# UNITED STATES PATENT AND TRADEMARK OFFICE

10/564,717

<b>Office Action Summary</b>	<b>Application No.</b> 10/564,717	<b>Applicant(s)</b> GRAVES ET AL.	
	<b>Examiner</b> MATTHEW LAWSON	<b>Art Unit</b> 3775

## DETAILED ACTION

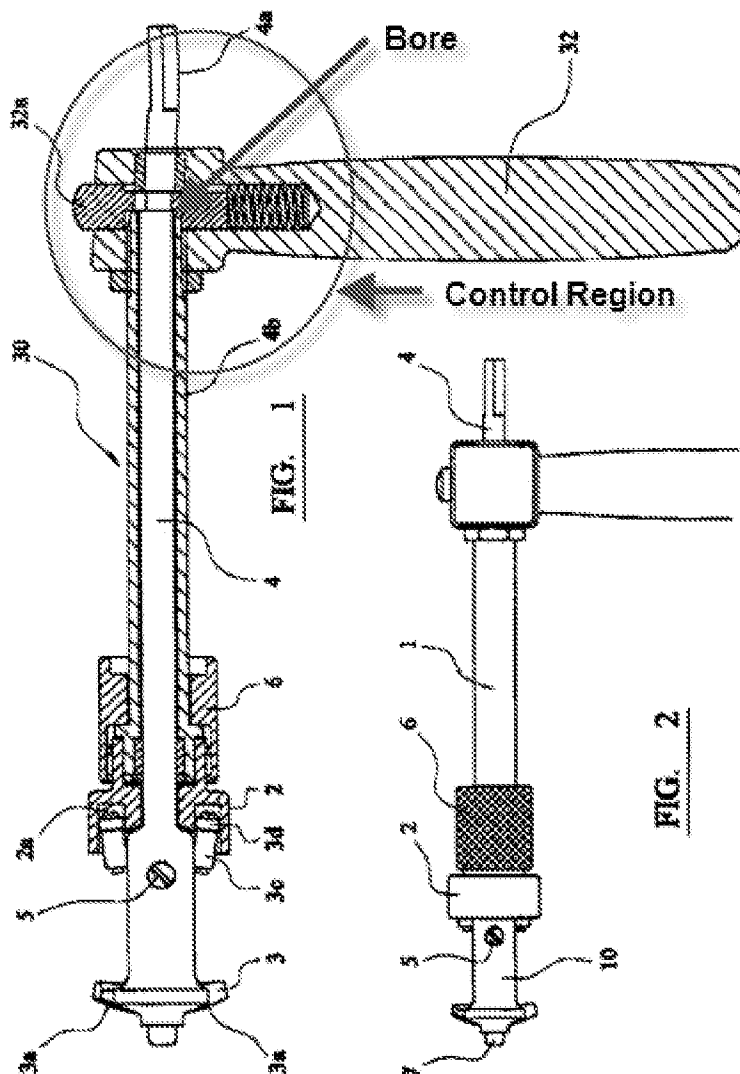
5. Claims 1-10 and 13-15 are rejected under 35 U.S.C. 102(b) as being anticipated by Sonnabend et al. (WO 01/34040).

Sonnabend et al. disclose a bone resection device having a cutting tool housing (10, figure 2), at least two cutting tools (3, figure 5) which are fastened to the housing so it is capable of being moved reversibly between a retracted position (figure 4) and an extended position (figure 5), in which the cutting tools extended further from the housing in the extended position than in the retracted position. The resection device also having an elongated shaft (4, figure 1) to which the cutting tool housing is attached to at one end; the shaft having a control region (see figure below) at the opposite end and the resection device is controlled while the cutting tool housing is located in the vicinity of the target bone tissue. The device further having a device for controlling the position of the cutting tool 6, figures 1-2) relative to the shaft along the axis of the shaft and is capable of being moved relative to the shaft along the axis defined by the shaft and being capable of rotation relative to the shaft around the axis (page 7, paragraph 2). The controlling device also engages the cutting tool by means of a cam arrangement (2, figure 1-2) in which the cutting tool has an elongated cam track (2a, figure 1) formed in it and the other has a reciprocating follower (3c, figures 1-2) which is capable of sliding in the track, the track being non-parallel to the axis of the shaft (page 7, paragraph 2) so that movement of the control device along the shaft causes relative movement of the follower along the cam track to cause the position of the cutting tool relative to the

housing to change (figures 4-5). The cutting tool is fastened to the housing pivotally so that it is capable of being moved pivotally between retracted and extended positions (figures 4-5, and page 7, paragraph 2), and the cutting tools are fastened to the housing in an opposed manner (figure 5) such that when one of the cutting tools is caused to move in one direction the other cutting tool is caused to move about the same degree in the opposite direction (figure 5). The device further having a handle (32, figure 1) with a bore (see figure below) extending through it in which the shaft is mounted for rotation, and the movement of the control device relative to the shaft is controlled by means of a cam surface (3d, figure 1) extending in a plane generally perpendicular to the axis defined by the shaft and a cam follower, in which one of the cam surface and the follower is fixed relative to the handle, and the other is fixed relative to the control device (6, figure 1), relative rotational movement between the control device and the handle causing the follower to move over the cam surface, and causing relative axial movement between the control device and the shaft (page 7, paragraph 3). The cam surface (3d, figure 1) is provided on the control device (6, figure 1) and the cam follower (3c, figure 1) is fixed relative to the shaft (4, figure 1) and the cam surface is provided on a part capable of being removed from the device. The device includes a locking mechanism (32a, figure 1) for locking the axial position of the shaft relative to the handle, and the locking mechanism further is capable of being adjusted to provide different locked axial positions of the shaft relative to the handle. The shaft also includes a connector formation (4a, figure 1) which is capable of being connected to a drive unit for imparting rotational movement of the shaft (page 7, paragraph 1). The

cutting tool is generally elongate in shape with a cutting edge (3a, figure 1) towards one end and the cam tracks (3c, figure 1) are opposite each other, the device also includes a protruding boss (7, figure 2) aligned with the shaft and provided on the end which is removed from the shaft (page 7, paragraph 3).
